SUBJECT: AMENDMENT NO. 120 TO FACILITY OPERATING LICENSE NO. DPR-43 -
KEWAUNEE NUCLEAR POWER PLANT (TAC NO. M90349)

Amendment No. 120
License No. DPR-43

SAFETY EVALUATION BY THE OFFICE OF NUCLEAR REACTOR REGULATION
RELATING TO AMENDMENT NO. 120 TO FACILITY OPERATING LICENSE NO. DPR-43

**FIGURE TS 3.1-4
 LOW TEMPERATURE OVERPRESSURE PROTECTION CURVE
 APPLICABLE FOR PERIODS UP TO END OF OPERATING CYCLE 21**

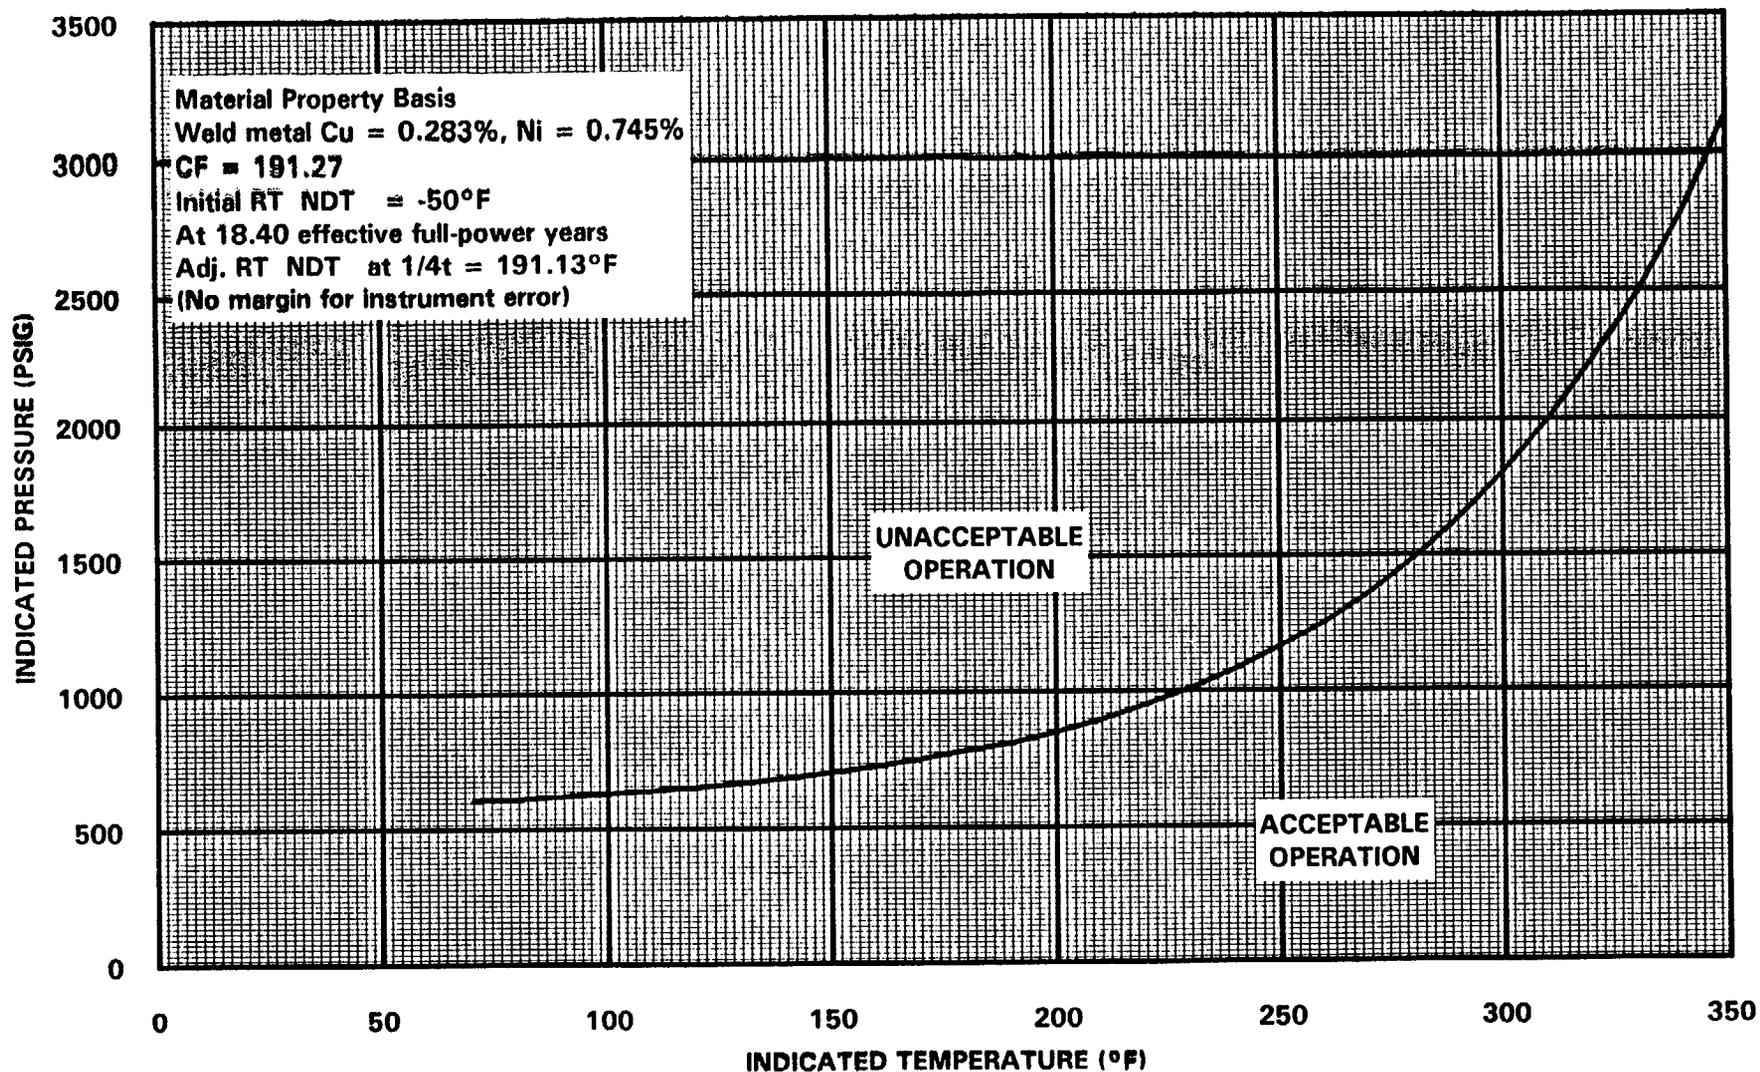
The amendment revises KNPP TS 3.1.b.1 and Figure TS 3.1-4 regarding Low Temperature Overpressure (LTOP) protection for the reactor coolant pressure boundary. The change extends the LTOP requirements through the end of operating cycle 21 or 18.40 effective full power years. The Basis Section has also been modified to reflect these changes.

By letter dated August 24, 1994, as supplemented on January 23, 1995, Wisconsin Public Service Corporation (WPSC), the licensee, requested a revision to the Kewaunee Nuclear Power Plant (KNPP) Technical Specifications (TS). The proposed amendment would revise KNPP TS 3.1.b.1 and Figure TS 3.1-4 regarding Low Temperature Overpressure (LTOP) protection for the reactor coolant pressure boundary. Currently, the TS specify the LTOP pressure-temperature (P-T) limits through the end of operating cycle 20 or 17.14 effective full power years. The proposed amendment would extend the applicable period of the LTOP P-T limits to the end of operating cycle 21 or 18.40 effective full power years (EFPY), which is expected to occur about September 1996.

The staff has reviewed the licensee's estimated fluence to the end of cycle 21 and, since it was calculated in accordance with standard industry methodology previously docketed in WCAP-13257, finds it acceptable. The staff also finds that proposed changes to TS 3.1.b.1 and its associated basis, and to Figure TS 3.1-4 accurately reflect the extension of the LTOP requirements and are, therefore, acceptable.

1. The reactor coolant temperature and pressure and system heatup and cooldown rates (with the exception of the pressurizer) shall be limited in accordance with Figures TS 3.1-1, TS 3.1-2, and TS 3.1-4. Figures TS 3.1-1 and TS 3.1-2 are applicable for the service period of up to 20 effective full-power years. Figure TS 3.1-4 is applicable through the end of operating cycle 21 or 18.40 effective full-power years.

- C. Figure TS 3.1-4 defines limits to assure prevention of non-ductile failure applicable to low temperature overpressurization events only. Application of this curve is limited to evaluation of LTOP events whenever one or more of the RCS cold leg temperatures are less than or equal to the LTOP enabling temperature of 338°F.

The staff has performed an independent analysis to verify the licensee's proposed LTOP P-T limits. The staff concludes that the proposed LTOP P-T limits are valid up to the end of operating cycle 21 or 18.40 effective full power years, because the limits conform to the requirements of Appendix G of 10 CFR Part 50 and GL 88-11. Hence, the proposed LTOP P-T limits may be incorporated in the KNPP TS.
